From: HSP Consulting Engineers Ltd
To: Wrexham County Council Highways
Date: 23/06/2023
Subject: **Transport Technical Note for Land East of Nags Head, Bettisfield. Proposed Residential Development (Erection of 4 dwellings).**

**Land East of Nags Head, Bettisfield.
Proposed Residential Development (Erection of 4 dwellings).**

From: Chief Officer, Environment & Technical **To:** Chief Officer Planning & Regulatory
Our Ref: ET/DC/PP/P/2022/0002 **Your Ref:** SJG/P/2022/0002
Date: 24th May 2022

STATUS	For Information
CLIENT	Taylor Reed Homes Ltd
PROJECT	Bettisfield
TITLE	Delivery Vehicle Tracking (Sheet 1 of 2)

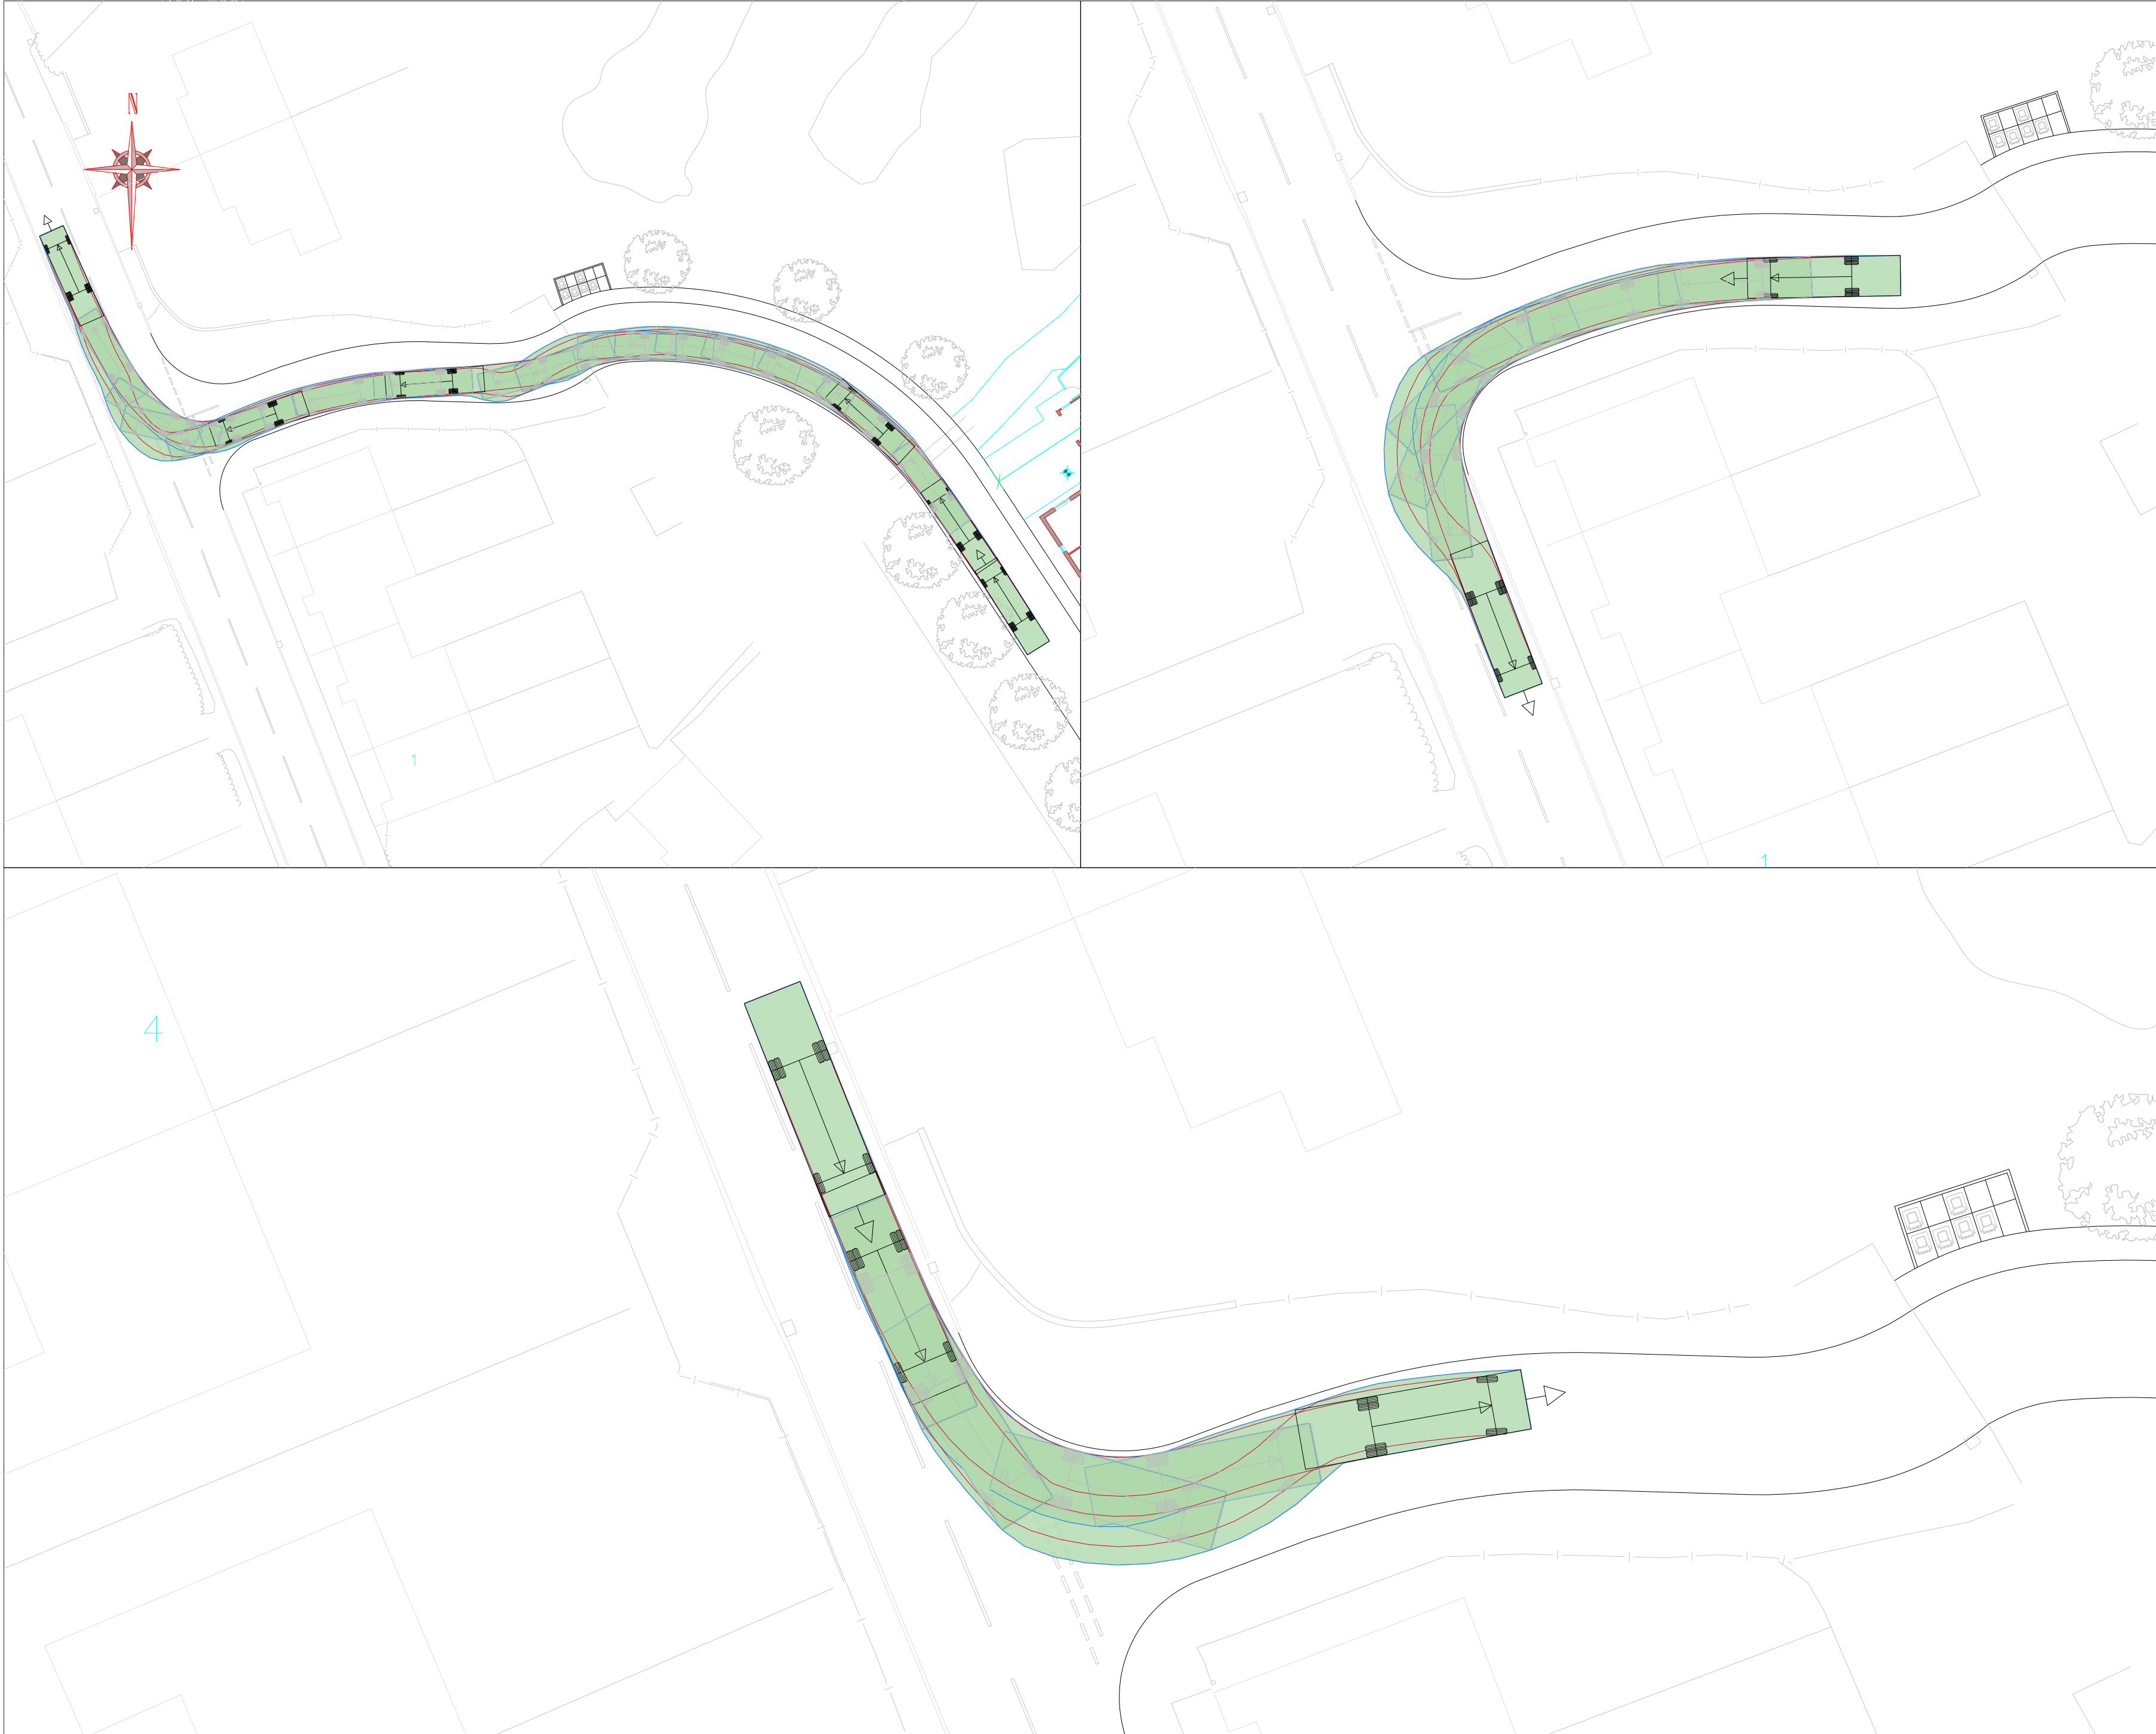
Any proposed turning heads normally need to be able to accommodate the turning movements of an 11.2m long refuse vehicle. Given the non-standard layout of the site, the estate road would not be considered suitable for adoption and would need to be maintained by a private management company in perpetuity. The latest submitted plans included provision for a turning head which can accommodate the turning movements of an 8.6m long fire tender and an 8 long delivery vehicle. Swept path details have previously been submitted indicating the movements of an 11.2m and 7.9m long refuse vehicle, 8m long delivery vehicle and car maneuvering within the site which appear acceptable.

As our waste / recycling vehicles do not normally enter private access roads, I assume that any waste / recycling services would need to be dealt with by a private company. I would recommend that the applicant discusses this issue with our Waste Strategy Officer – Catherine Golightly on Tel: 01978 729693. I understand that you have discussed / agreed a suitable bin store with our Waste Strategy Officer whereby collection is proposed from the main road. **Any proposed bin store facilities will need to be detailed on a revised layout plan. If the above waste collection arrangements are considered acceptable, then an internal turning head capable of accommodating an 8.6m long fire tender and 8m long delivery vehicle would be considered acceptable**
